Meeting Agenda

Franklin Municipal Planning Commission

Thursday, May 26, 2022

8. 1624 West Main Street PUD Subdivision, Site Plan (Bookers Corner), Creating 6,500 Square Feet Of Commercial Space, On 0.78 Acres, Located At 1624 West Main Street. (CONSENT AGENDA)

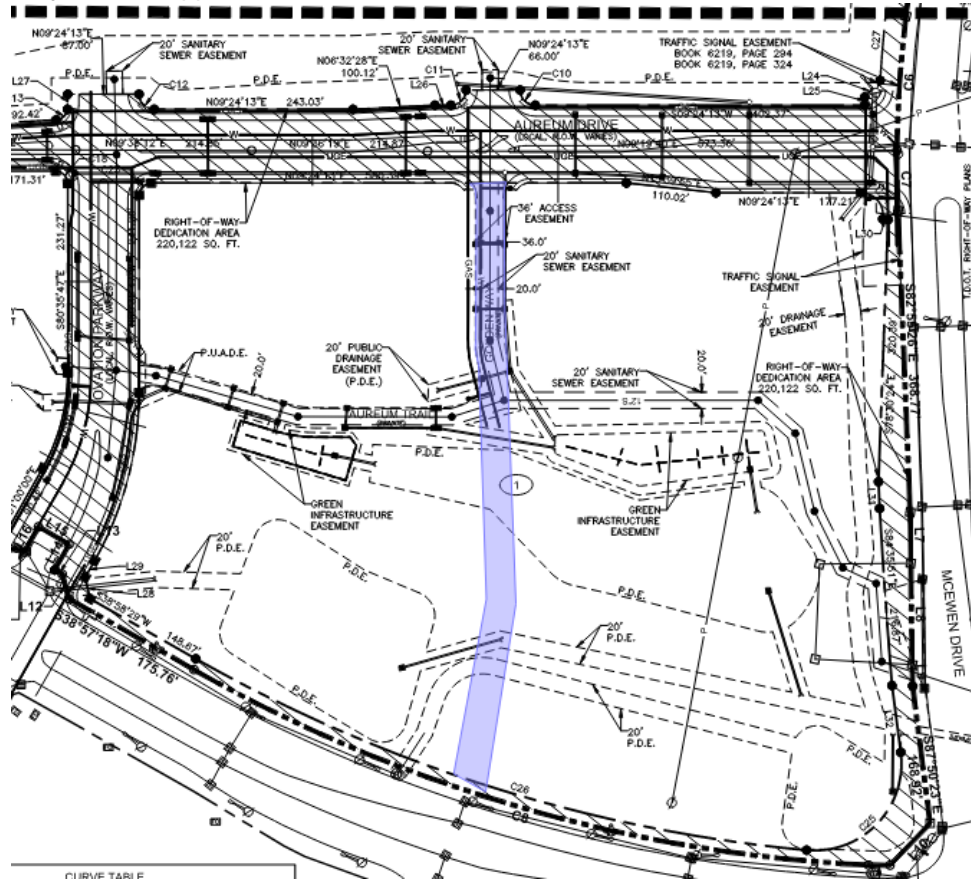
Street name approval for the private street highlighted below is pending. With the submittal to One Stop, the Applicant shall revise General Note 19 to replace "Golden Way" with the approved street name:

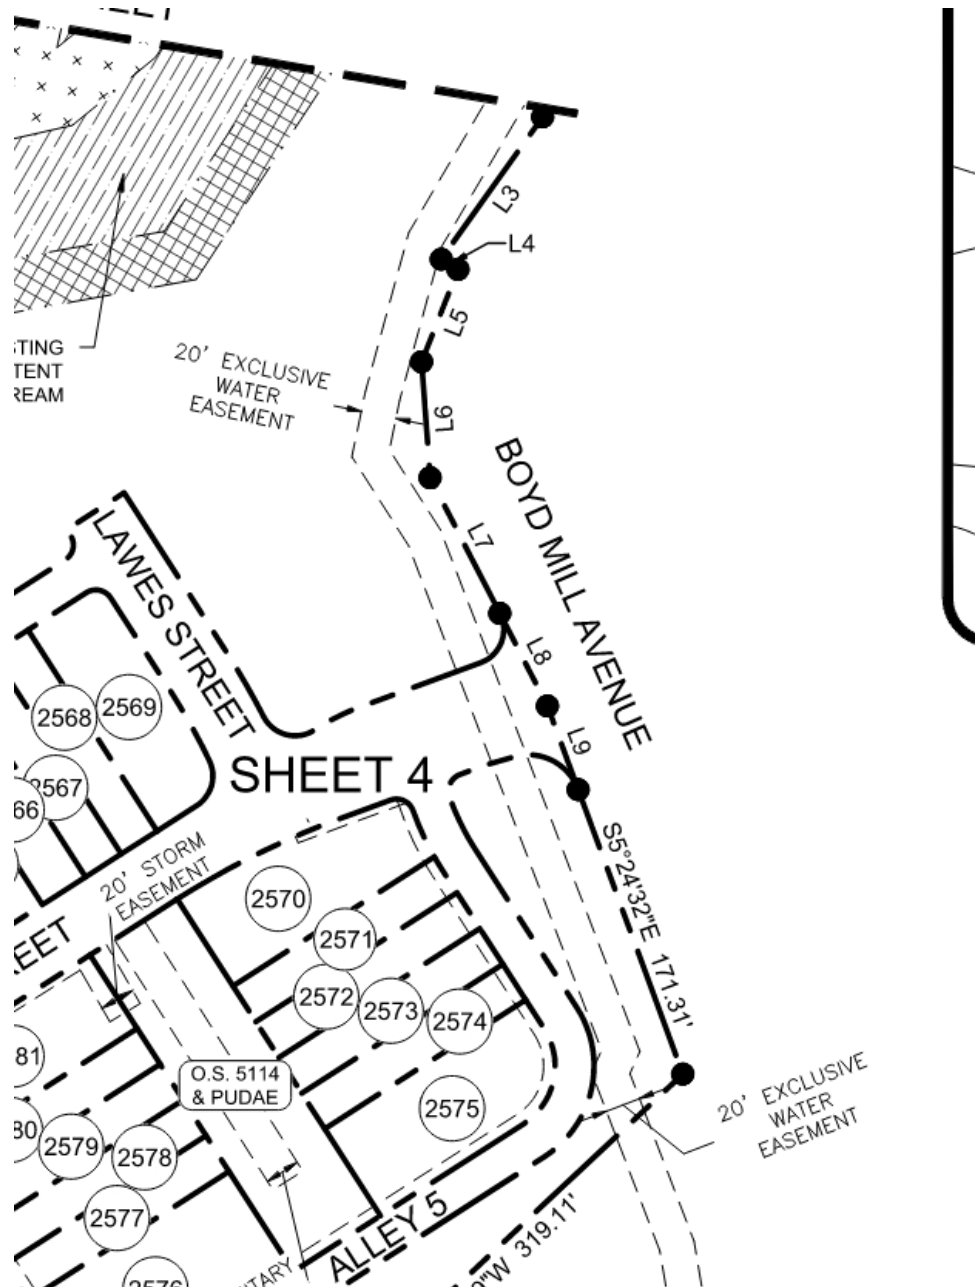
jeff.willoughby@franklintn.gov Centerline and top of bank of stream shall be labeled.

21. C. Final Plat

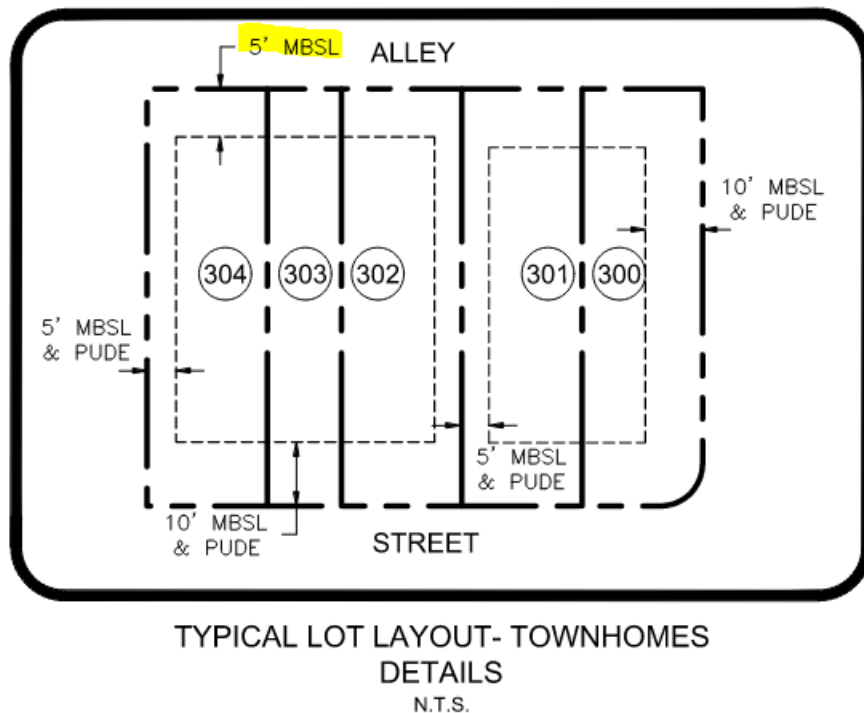
lance.fittro@franklintn.gov Applicant shall indicate the MBSL on the Typical Lot Layout highlighted below as a PUAE:
